SFMTA
Municipal
Transportation
Agency

RE: Upper Market Street Safety Project Response to DTNA Feedback

UPPER MARKET SAFETY IMPROVEMENTS FEEDBACK

Proposed Circulation Changes on Upper Market Street at 17th/Castro, 16th/Noe and 15th/Sanchez Streets

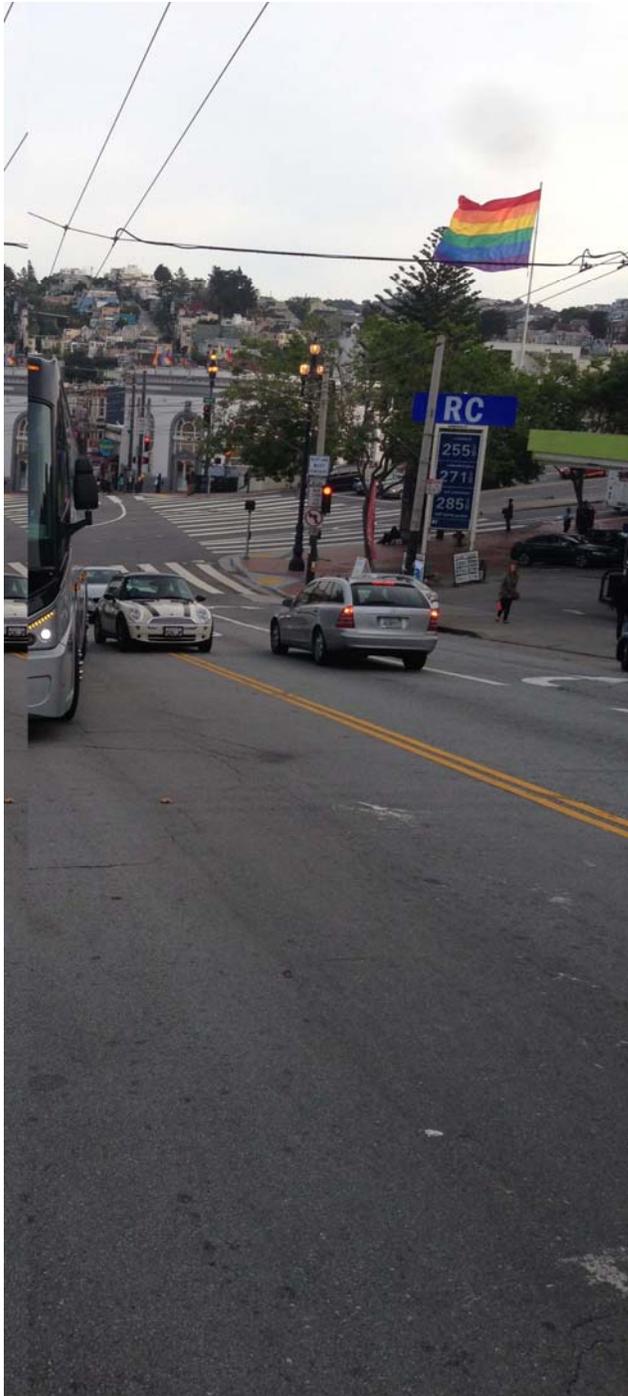
Bulbouts at 15th/Sanchez/ Market Street are unnecessary and actually create a hazard for bikes. Cyclists are currently pinched Northbound on Sanchez in the approach to Market Street. Multiple neighborhood cyclists have noted that the current SFMTA proposal as creating an increased danger to an already dangerous approach. DTNA strongly recommends removing the bulbout in front of the pet store to prevent endangering cyclists.

The additional proposed bulbout at this intersection is at the Chase Bank and the Hecho restaurant. The crossing distance is currently completely acceptable and we see this as a waste of financial resources. The funding is critical to the safety of our neighborhood and these two bulbouts offer no gain. The planned bulbout at the current construction site of GreyStar is consistent and valid to serve pedestrians, cyclists and car circulation. We strongly urge you not to spend our money in pointless solutions looking for a problem.

More specifically, bulbs that have been proposed at Market and 15th Streets would shorten the crossing distances (and also the time required to get across the street) significantly:

- Crossing Chase to Hecho – approximately 15 feet shorter
- Crossing Chase to the new development on Market/Sanchez – approximately 6 feet shorter
- Crossing Hecho to new development on Sanchez – approximately 9 feet shorter
- Crossing south side of Market across Sanchez (at Verizon) – approximately 16 feet shorter

With that said, over the past year, SFMTA staff have evaluated and observed driver and pedestrian behavior surrounding these painted safety zones and have incorporated this information into our proposed design for concrete corner sidewalk extensions. For example, we have decided to eliminate plans for a concrete bulbout on the north side of 16th Street, just west of Market Street based on observed vehicle turning and through-movement behavior at 16th/Market Streets. The SFMTA will conduct conceptual design and procure cost estimates for the bulbout at the north corner of 15th/Sanchez Street in front of the Chase Bank Building and conduct a cost-benefit analysis to determine whether to move forward.

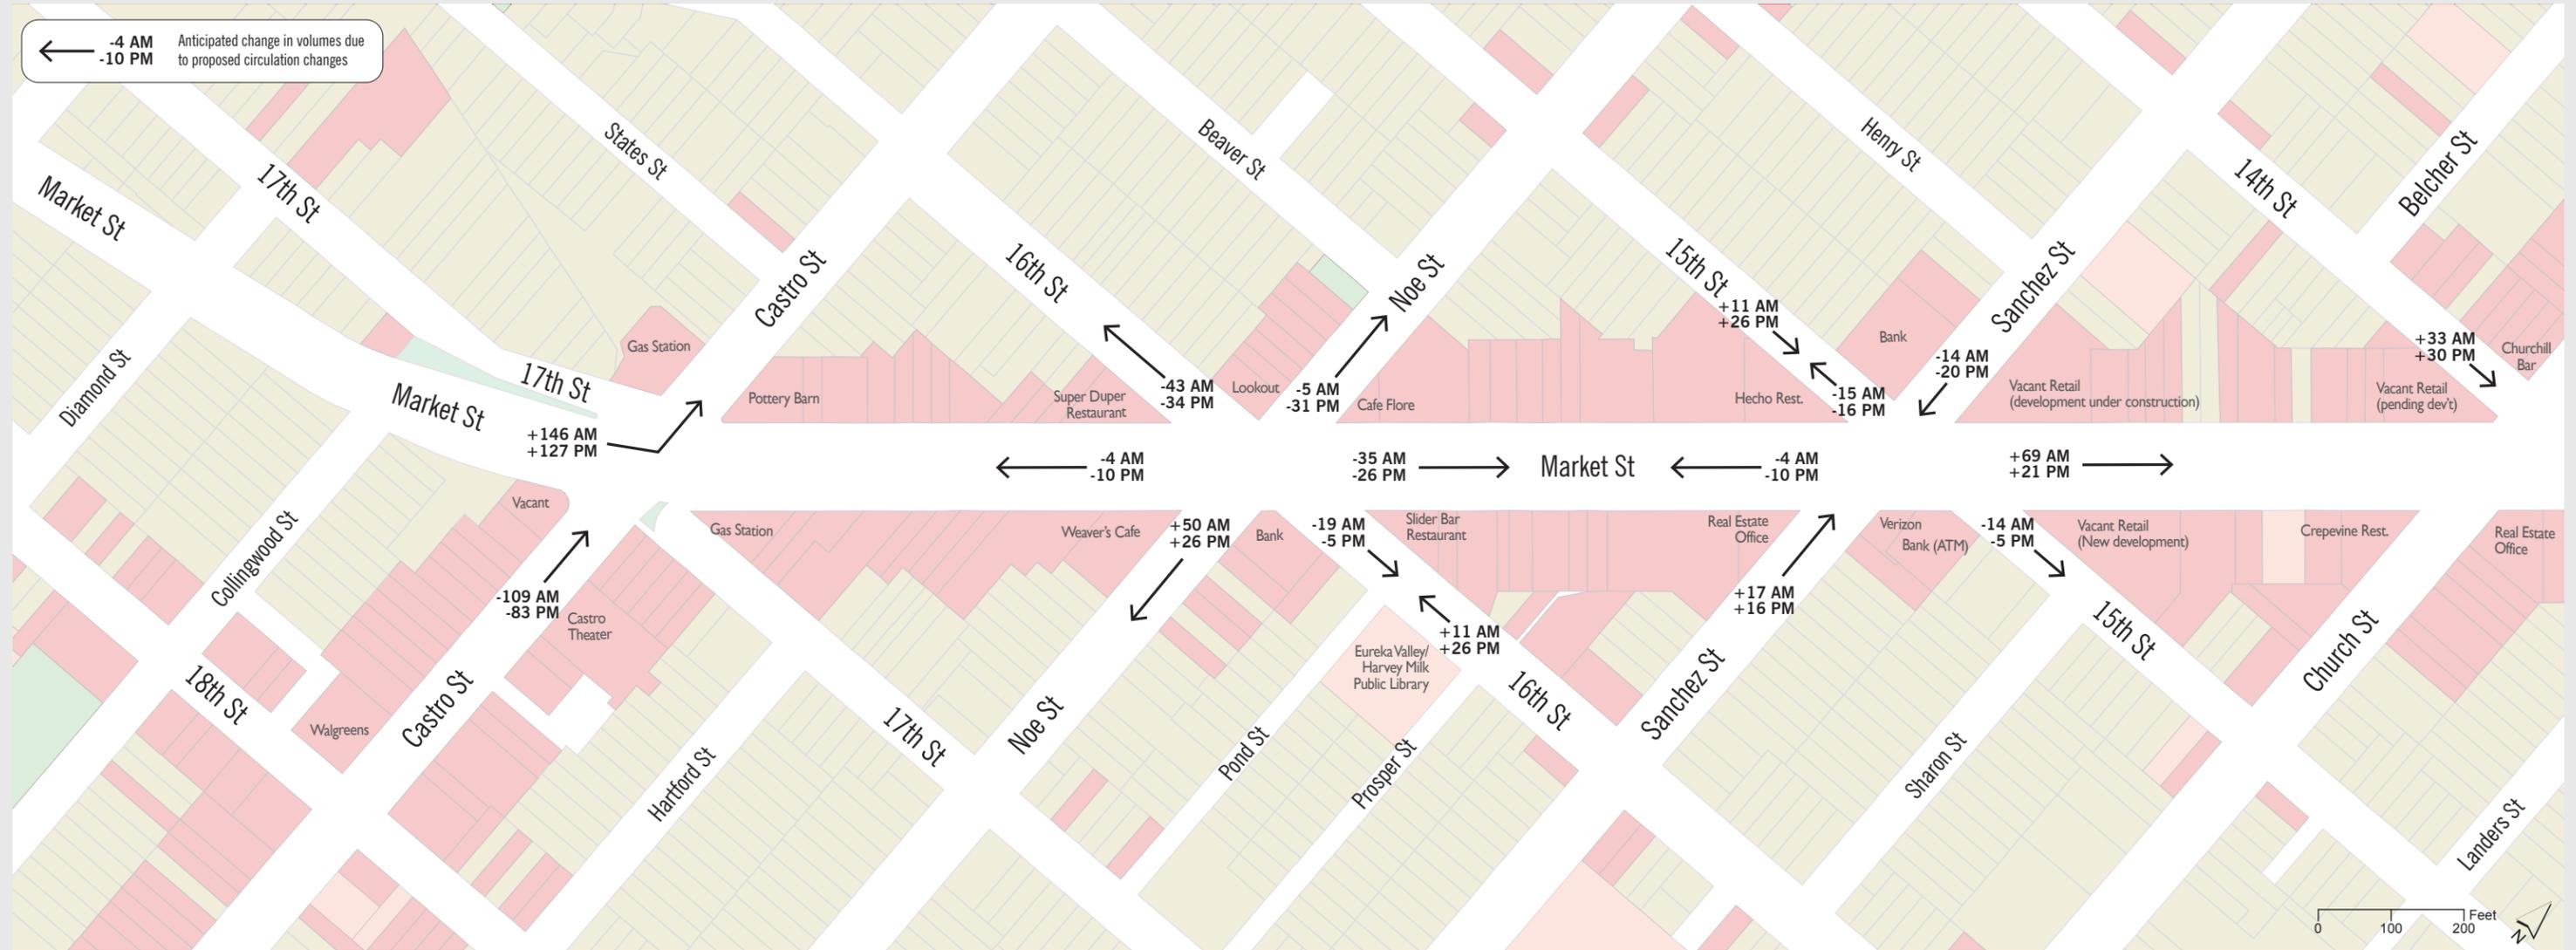
15th Street will experience higher volumes and more delays

- **Prohibit left turns** from Sanchez Street

- Reduce conflict points between people driving and walking in 15th and Market Street crosswalks
- Reduce conflict points between people driving and biking on Sanchez Street
- Simplify traffic flow for people driving on Sanchez Street
- Reduce queuing of eastbound Market Street vehicles in intersection
